From: William Ward
To: Frank Festa
Date: 8/2/01 5:50PM
Subject: Final questions

Review of you application is complete. I have 3 final questions as a result.

Source Label

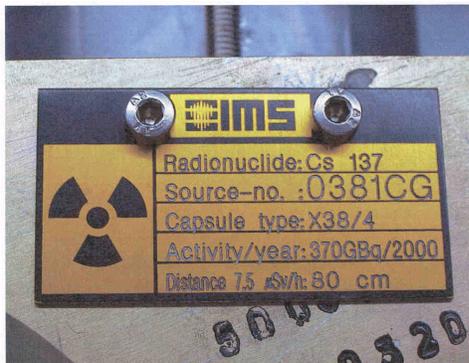
1. No "in-beam" radiation levels were given. Do you have any calculations or estimate to show what this would be?
2. Concerning the activity and date provided on your label, please state if you are entering an actual activity or a nominal activity and date? Is it possible to put month/year instead of just year? I've attached a copy of the label you sent with your application to make for easy reference.
3. Concerning your QA program (8/1 version sent to me is attached). It says it is "Manufacturer's Program Outline". I know that you, the distributor, are owned by IMS-Germany, the manufacturer. Please state to whom this program applies, or if it applies to both of you. Is all manufacturing related QA performed by the manufacturer at their facility?
